**OU1 Design Change and Modification Sheet:  
Change/Modification # 29**

Property ID: \_\_\_\_\_ Operable Unit 1 (Area 1)

DETAIL D  
NTS C6

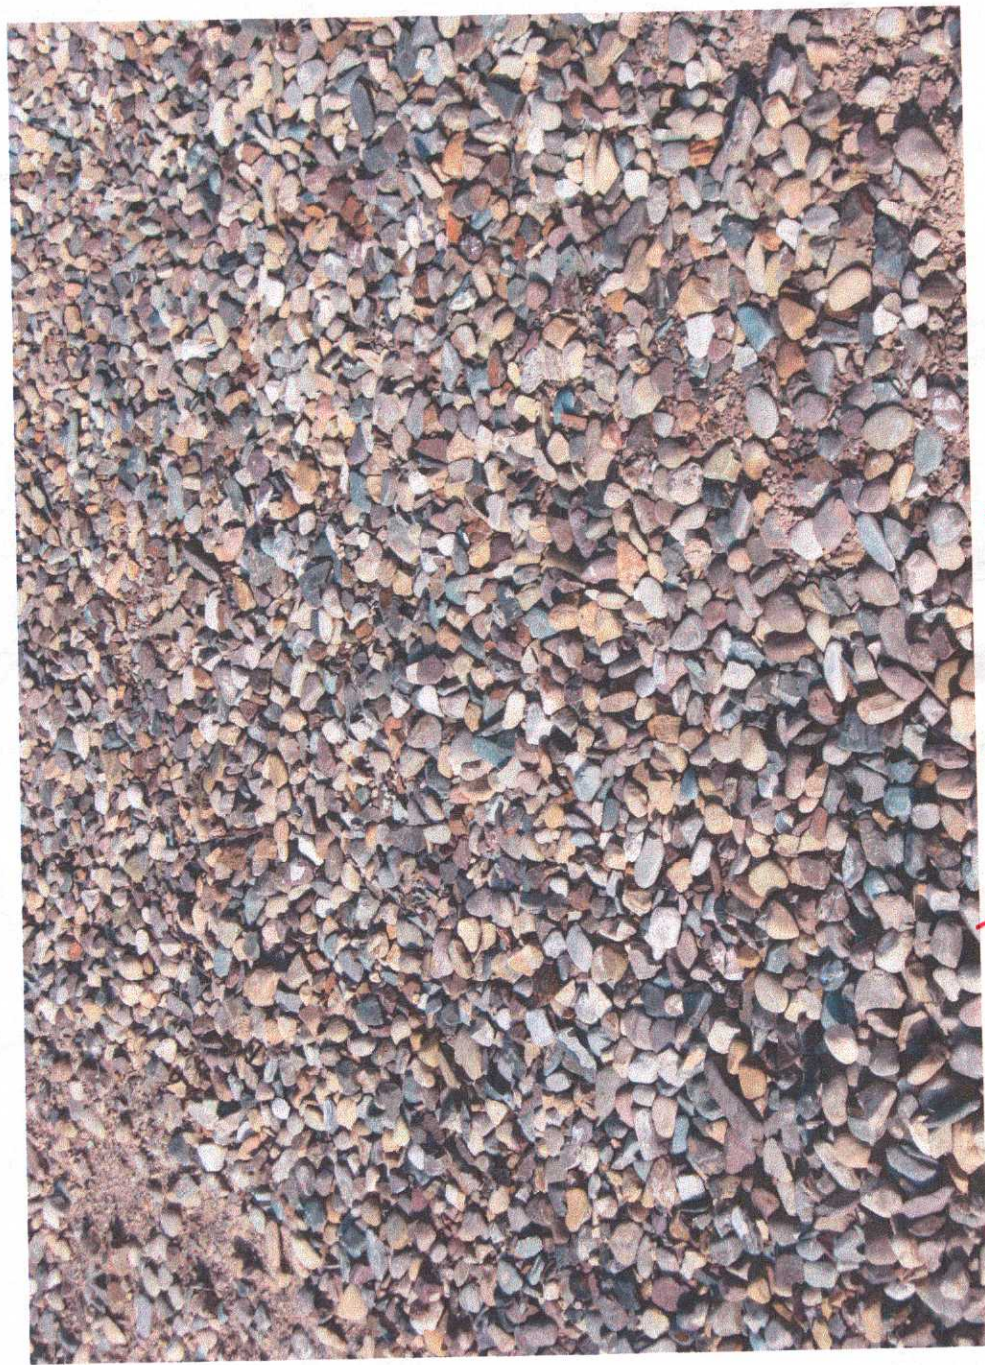
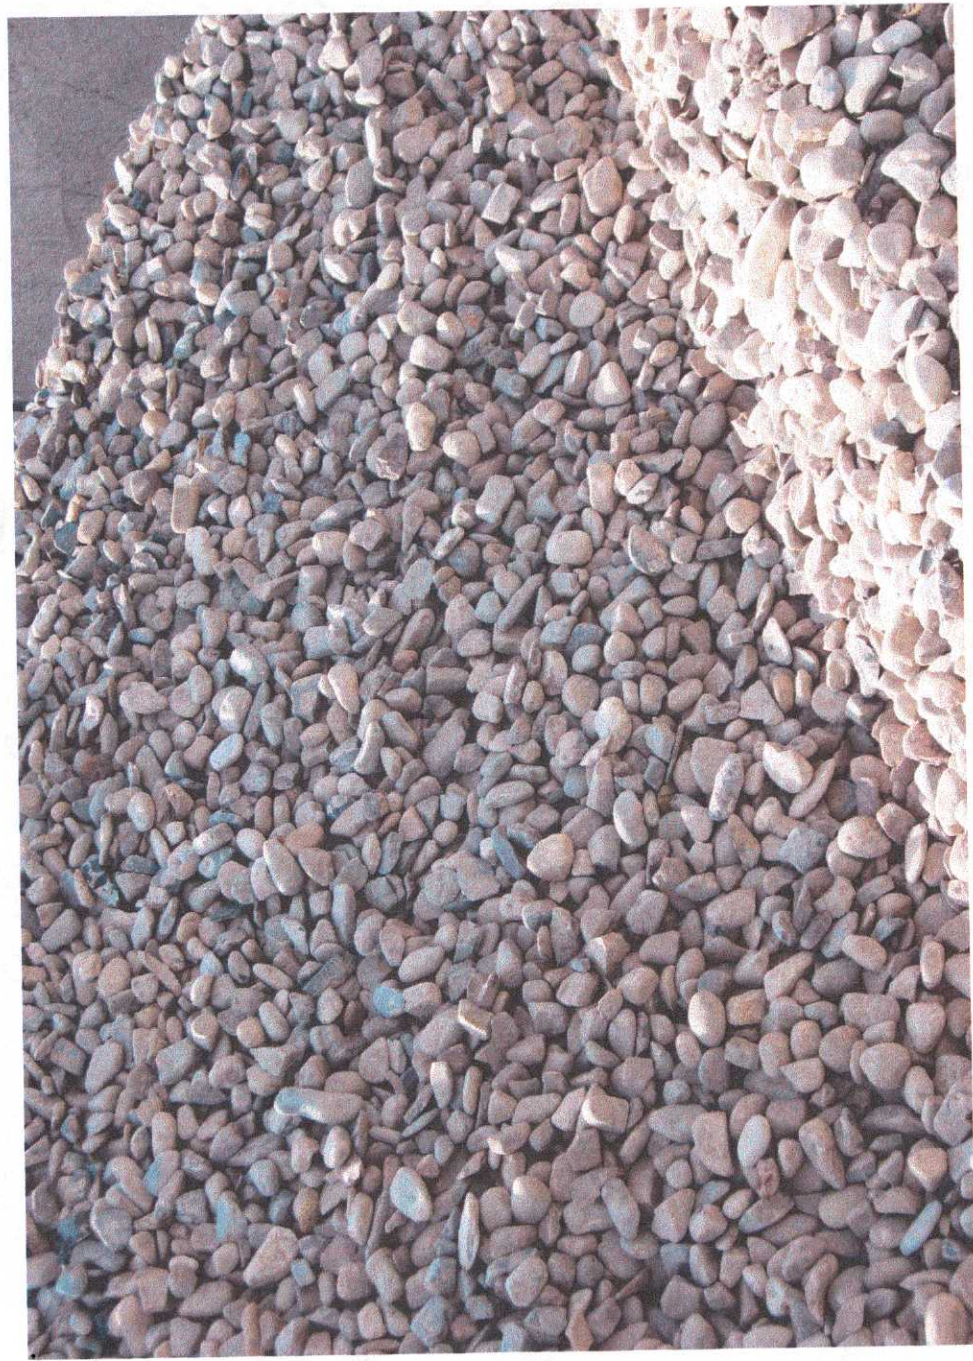
Detention Basin / Rock Trench, Sheet D2, Detail D. In an effort to maximize the useful life of the drainage features the final lift of cover material will be 6" of 1 ½" washed rock in lieu of the specified top soil cover.

*consider Leaving Wattles  
in place?*

*Leave in place - if City wants  
removed we will take care of it.  
H 5/24/2012*
